Changing thumbscrew of DIN rail mounting bracket (B-570)

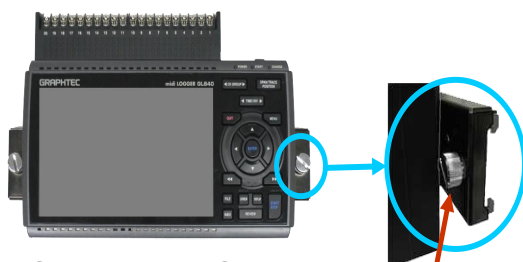
GL series can be mounted to DIN rail using mounting bracket B-570. The mounting bracket is fixed to rail by thumbscrew.

In this change, the knob size on the thumbscrew is changed, but the thread size of screw is not changed.

Note: this change applies to B-570 shipped after 8th December, 2017.

Current style

Large knob

New style

Small knob

Supported GL series: GL840, GL820, GL900, GL980, GL2000

* When using GL980 and GL2000, it is required to remove rubber cover.
